June 6, 2011

**Re: Proponent Responses to
Requests for the Minister of the Environment to Review the
Director of the Environmental Assessment and Approvals Branch's Decision to
Deny the Requests that the Proposed Project to
Build a Hydro-electric Generating Station at the North Bala Falls be
Elevated to Require an Individual Environmental Assessment**

Figure 1 – North Channel Showing Proposed Intake Trash-rack, Depth (as Contour Lines) and Red Line Showing Where Cross-sectional Area Was Calculated

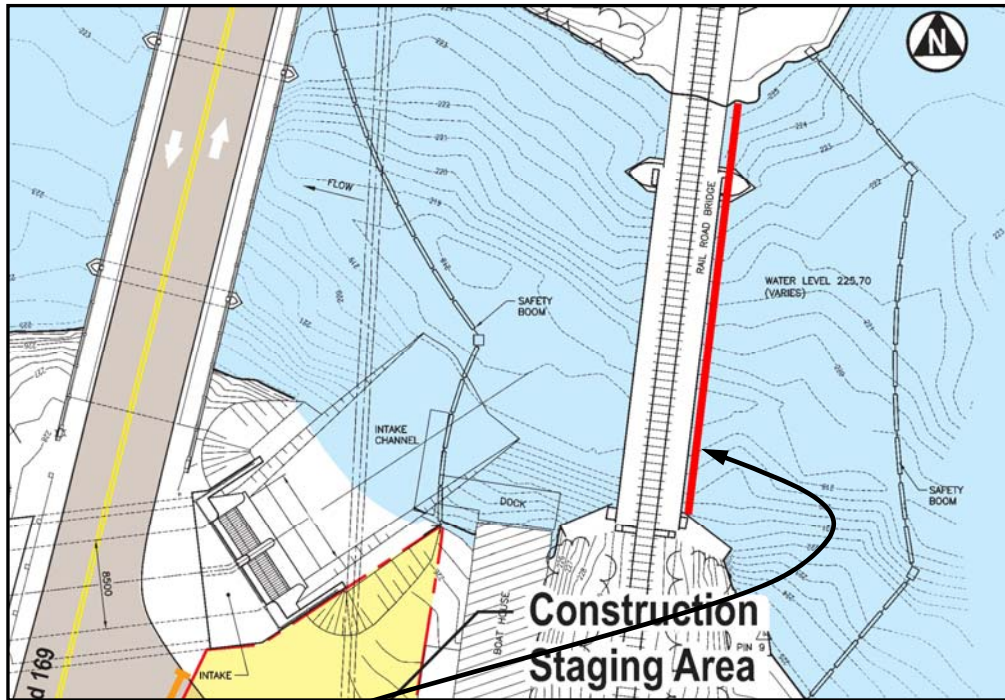
And, as shown in Figure 5.1 of their environmental screening report, the proposed trash-rack would be 13 m high, resulting in an intake cross-sectional area of 150 m². The cross-sectional area of the water in the north channel just upstream of the railway bridge (at the red line shown in Figure 1) is 162 m² (this was calculated using the channel depth information from Figure 1 and using this to construct Figure 2) – and this is just 7% greater than for the intake. Therefore, the water velocity across the **full width of the north channel would be almost the same as directly at the very dangerous trash-rack**. There are many significant implications of this:

- a) The shoreline at the town docks and at Diver's Point upstream of the safety boom – where, according to the proponent and the Ministry of the Environment, it would be safe for all types of in-water recreation – is just 20 m upstream from this dangerously fast water at the railway bridge. And the current could carry someone 20 m in less than a minute.

- b) Fish using their "*burst swimming capacity*" (as stated in Section 6.2.5.6 of the environmental screening report) to escape entrainment into the proposed turbine would not just be darting to the side of the trash rack, but would need to swim more than 60 m upstream to safer slow water, due to the long narrow channel upstream of the intake.
